# AMERICAN BATTLE MONUMENTS COMMISSION INTERPRETIVE CENTER HONOLULU MEMORIAL NATIONAL MEMORIAL CEMETERY OF THE PACIFIC

A Concept submittal was presented in February 2023. Current submittal is to illustrate how the team has addressed comments:

U.S. Commission of Fine Arts  
June 1, 2023 | 07

## EXTERIOR WALLS

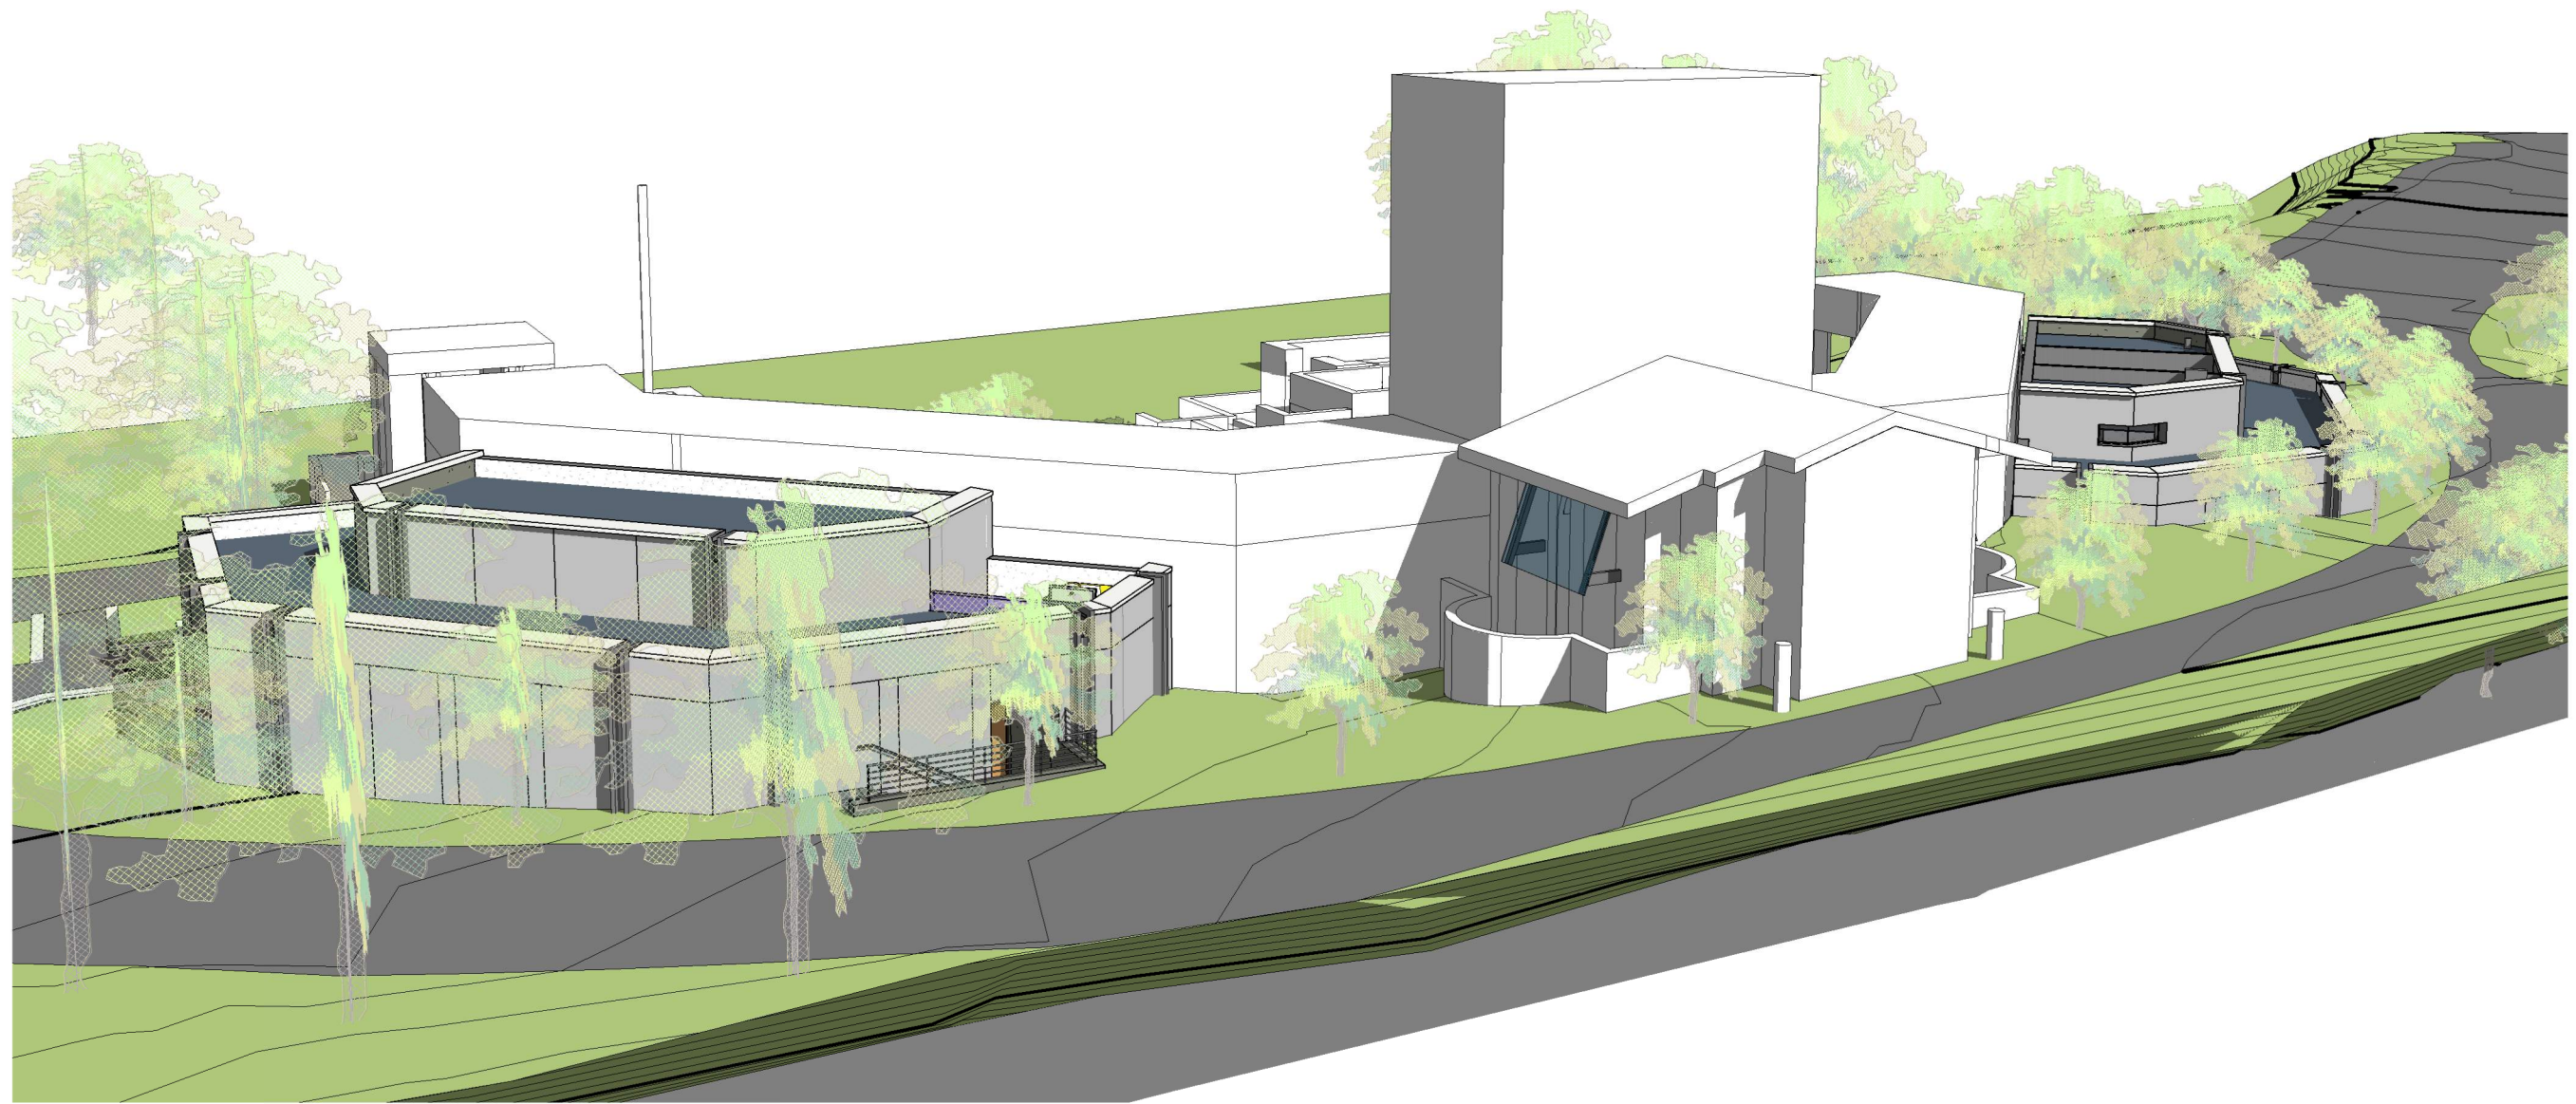
- Facades at perimeter road: Organically-patterned precast concrete appears to compete with landscape
  - + Changed pattern to allude to the map gallery rhythm.

The majority of the exposed walls are proposed to be of exposed aggregate precast concrete panels. The finish will be similar to the Courts of the Missing Wall as shown. The aggregate consists of basalt stone and is slightly darker than the rear of the Memorial. The pattern of the panels will be done to allude to the rhythm of the map gallery on the Upper Court side.
